No.: 07 TS-59
November 19, 2007

SUBJECT: **EPA98 and EPA04 MBE 4000 Flywheel Housing Mounting Bolts**

Figure 1 – Flywheel Housing Engine Mount Holes

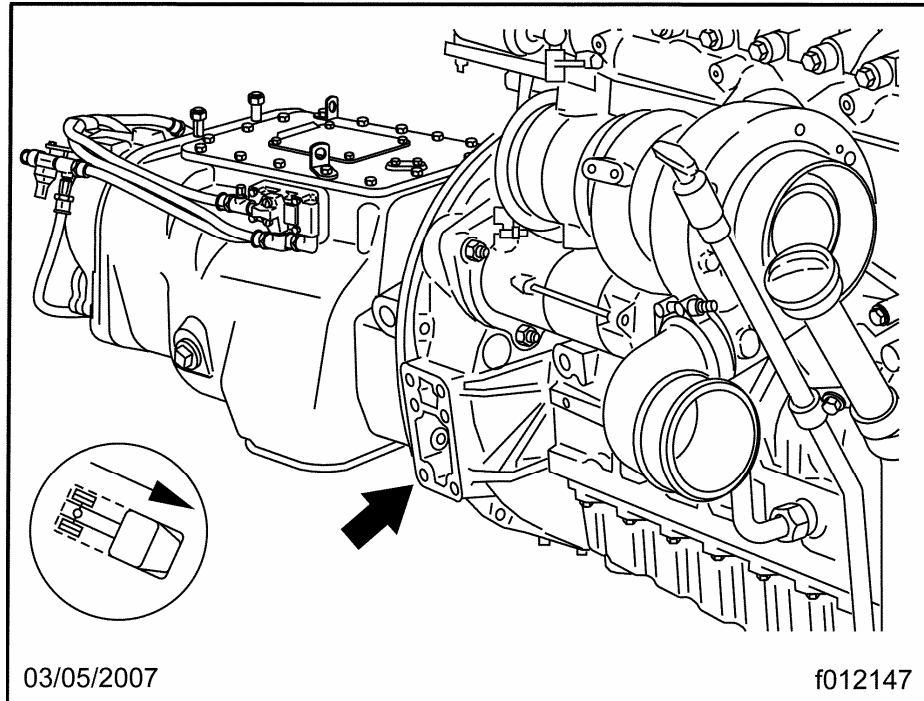
Changes in fastener length, installation procedures, and bolt torque have been implemented in production to address rear engine mount fasteners loosening in service. Engines built prior to engine serial number 0460750202 on May 13, 2003, use a flywheel housing that only accommodates 40 mm M16 x 1.5 bolts in the upper and lower tapped mounting bracket attachment holes in the flywheel housing. Engines built after this serial number require 50 mm bolts.

All remanufactured MBE 4000 reliabilt[®] products with a serial number greater than 460000R3001044 (built in July, 2004) must also use 50 mm bolts, even if the vehicle was originally equipped with 40 mm bolts.

The correct length bolts must be used with the correct flywheel housing when repairs are made.

1. Use the engine serial number and a measurement to determine the correct flywheel housing bolts needed.
 - a. If the engine serial number is less than 0460750202 (built before May 13, 2003), 40 mm bolts must be used.

- b. If the engine serial number is 0460750202 or greater (built on or after May 13, 2003), 50 mm bolts must be used.
 - c. Double check the depth of the hole by using a suitable dowel rod or bolt.
